ADDENDUM NUMBER ONE

Indiana University
Launch Accelerator for Biosciences
1302 Indiana Ave.
Indianapolis, IN 46202

Addendum Dated: OCT 16, 2025

IU Project #: 20250072
BSALS Project #: 00360481

S110B

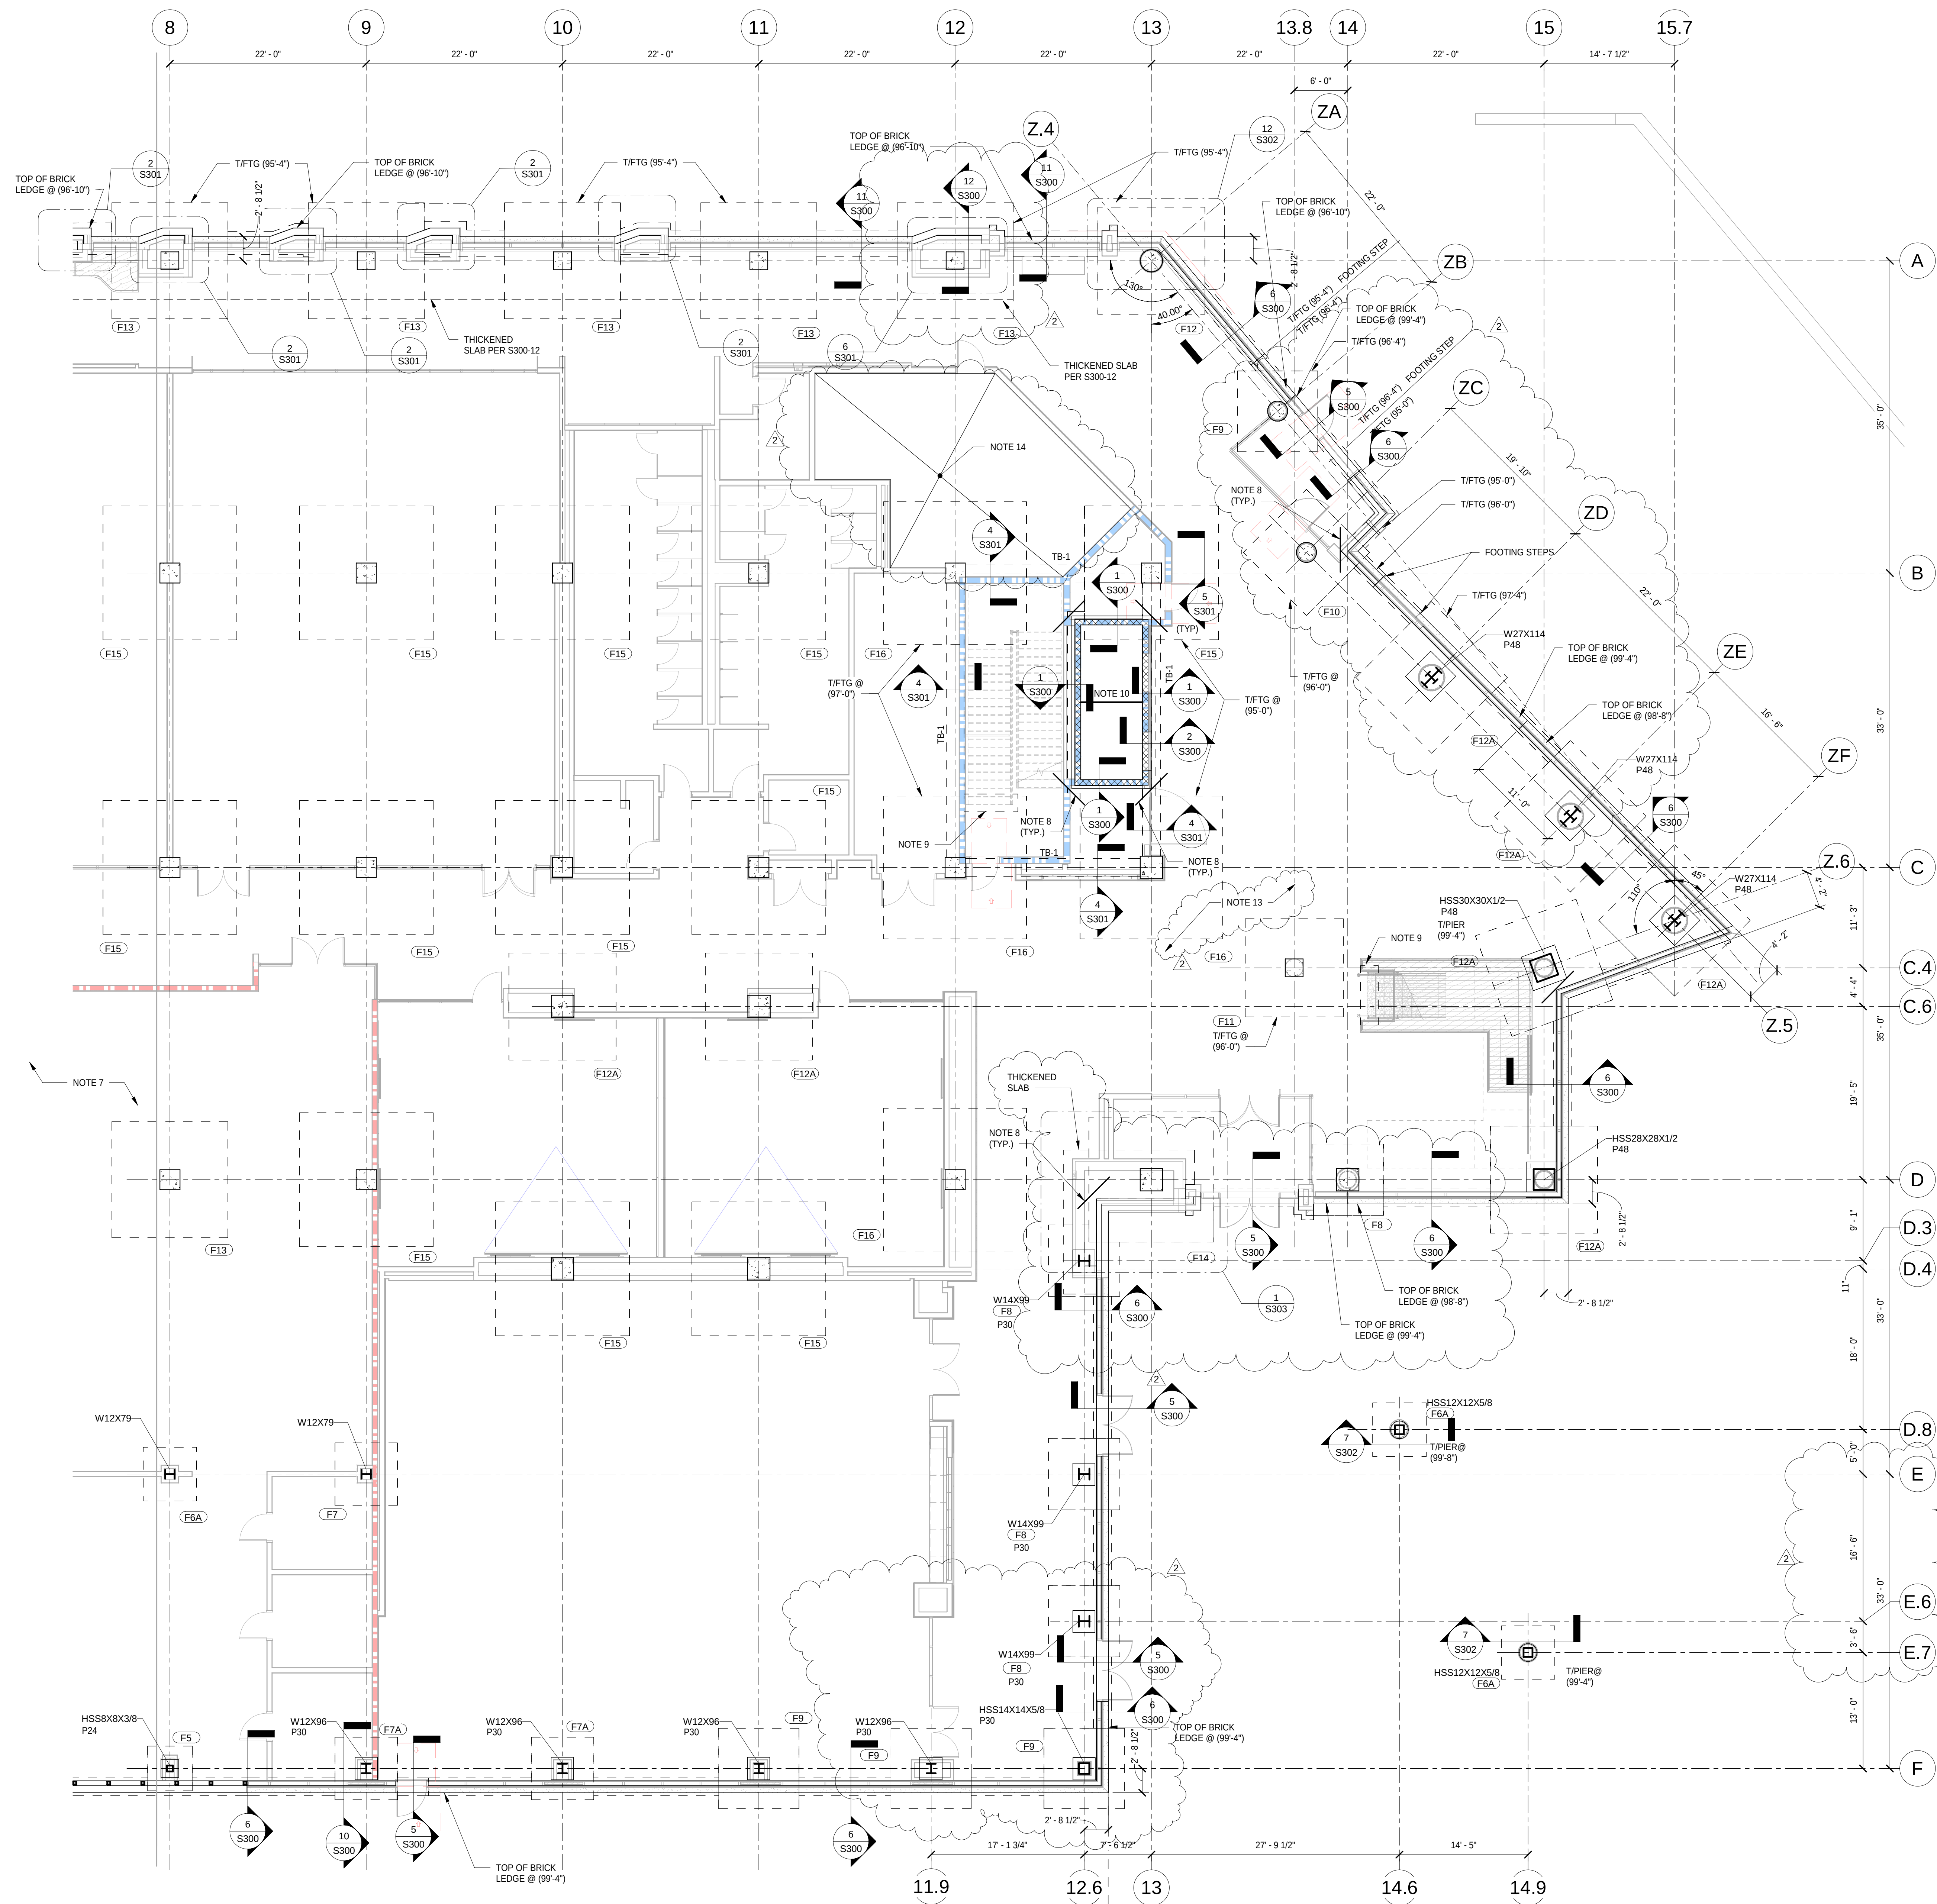
- a. Omit hatch pattern on the slab on grade near column line 14/C. Refer to future bid packages for dimensions and locations of recessed slabs for terrazzo flooring.

- b. Omit the slab on grade near column line 12/B. Add note 14 at this location stating to omit this slab until future bid packages.
 - c. The step in the brick ledge along Z.4 line should occur at column line ZB. Notes and leaders were modified to reflect this location.

- d. Delete section cut S300-05 along Z.5 line near ZD line. There is no door or stoop at this location.
 - e. Extend thickened slab near D.3 and 12.6 lines to cover the increased foot print of the masonry enclosure around this column.

- f. Modify door locations and add columns and footings along 12.6 line as shown on the clouded portion of the attached revision drawings.
 - g. Add a column, pier, and footing at F/11.9 lines as shown on the clouded portion of the attached revision drawing.

- h. Add a column, pier, and footing at 12.6 and E.6 lines as shown on the clouded portion of the attached revision drawing.
 - i. Add brick ledge step along Z.5 line between ZE and ZD lines as shown on the clouded portion of the attached revision drawing.

- j. Add brick ledge step along D line at 14 line as shown on the clouded portion of the attached revision drawing.
12. **Sheet S300:**
- a. Modify the "PER PLAN" dimension line on S300-06 as shown on the clouded portion of the attached revision drawing.
